| Request | - | Special Use Permit for Gasoline and Fuel Sales |
| Location | - | 1322 Bernath Parkway |

STAFF ANALYSIS

SPECIAL USE PERMIT
TOLEDO CITY PLAN COMMISSION
REF: SUP25-0049
DATE: March 12, 2026
TIME: 2:00 P.M.

L1.0

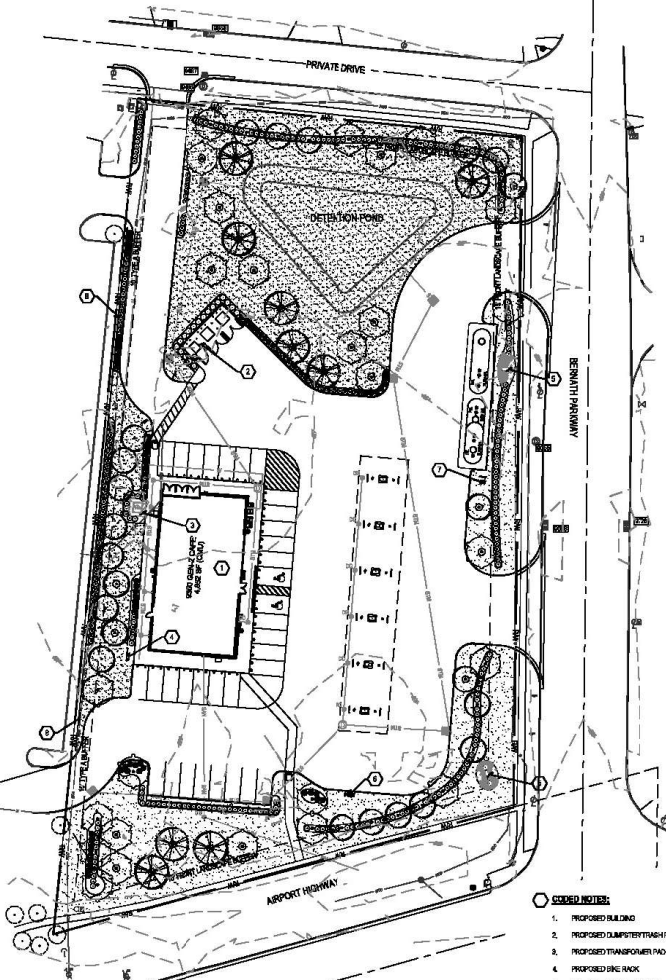
A Type A landscape buffer is required along the western property line. This landscape buffer shall be a minimum ten (10') feet in width and include a solid fence or wall six (6') to eight (8') feet in height, and plantings of four (4) trees and fifteen (15) shrubs for every one hundred linear feet (100'). The western property line is ± 488 linear feet, requiring twenty (20) trees and sixty (60) shrubs. The landscape plan depicts a six (6') foot tall wall, with thirteen (13) trees and seventy-eight (78) shrubs. An additional seven (7) trees shall be provided as a part of the Type A landscape buffer along the western property line, and is listed as condition of approval.

- b. A ten-foot (10') wide Type A landscape buffer consisting of a solid wall or fence six-feet (6') to eight-feet (8') in height, four (4) trees and fifteen (15) shrubs for every one-hundred (100) linear feet shall be provided along the western property line abutting the residential district. **The proposed width, wall, and number of shrubs is acceptable however, an additional seven (7) trees shall be provided.**

- e. Foundation plantings shall be required along the portions of the building visible from the right-of-way. **Acceptable as depicted.**
 - f. Plantings at the main entrance of the building shall be provided. **Not acceptable, shall be depicted on revised landscaping plan.**

- n. The location and direction of any proposed lighting. **Lighting is to be directed away from adjacent residential properties.**
 - o. Per TMC§1108.0203(G), dumpsters shall be screened on all four sides with materials of evergreen plantings, fencing, a wall, or a combination thereof with a minimum height of six (6') feet. **Not acceptable, dumpster screening detail and materials shall be submitted for approval on revised landscaping plan.**

SHEET:
A3.3

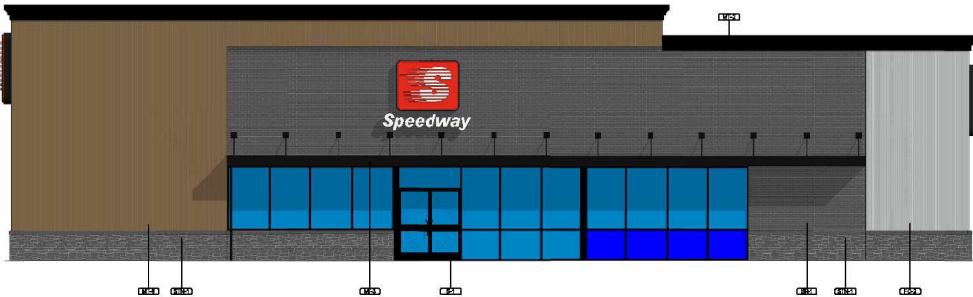
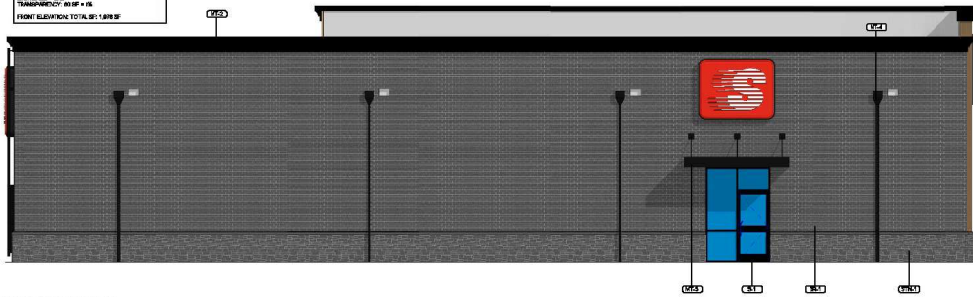
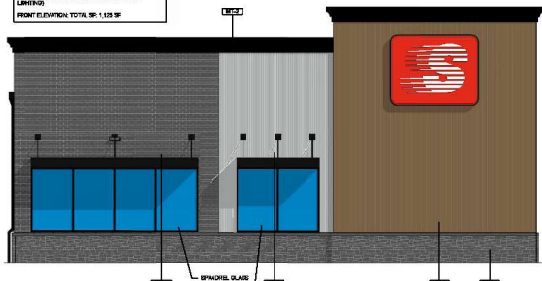
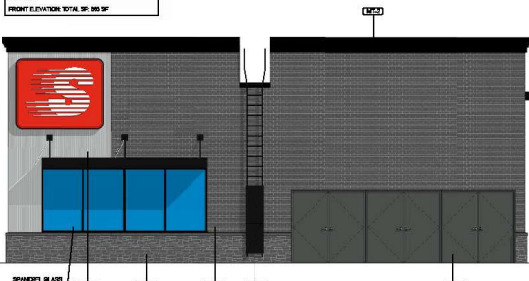
The proposed architectural metal is indicated as a twenty-four (24)-gage face sheet. Per TMC§1109.0502(D)(4) – metal panels shall have a minimum twenty-two (22)-gage face sheet. The use of twenty-four (24)-gage architectural metal is not permitted and is listed as condition of approval.

39. Per TMC§1109.0502(D)(4) architectural metal panels shall have a minimum twenty-two (22)-gage face sheet. **Not acceptable as depicted on building elevations.**
